Technical Service Bulletin

MODEL(S) T7 AMR Autonomous Rider Scrubber

AFFECTED: Models manufactured before serial number 10981578 (April 3, 2020)

SUBJECT: Off-board charger interlock switch failure (i.e. damaged or loss of adjustment). The failure may occur if the charger connector is roughly connected or disconnected to and from machine. Switch failure will prevent machine from powering up.

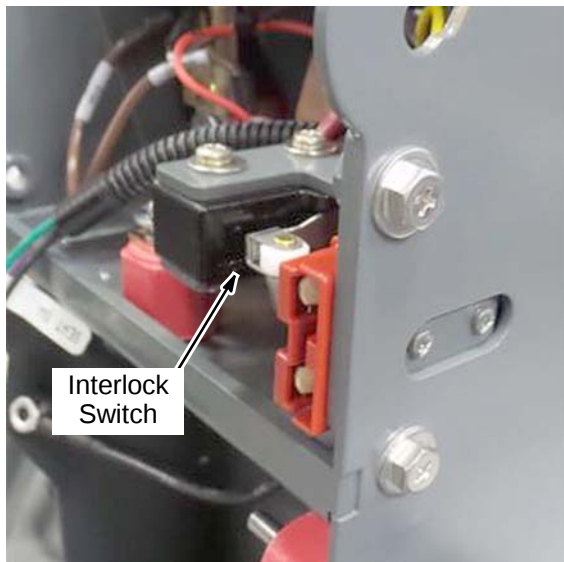
PURPOSE: To prevent potential interlock switch failure, install Replacement Switch Kit 9020923. The kit includes a guide connector bracket to protect switch from failure as shown below.
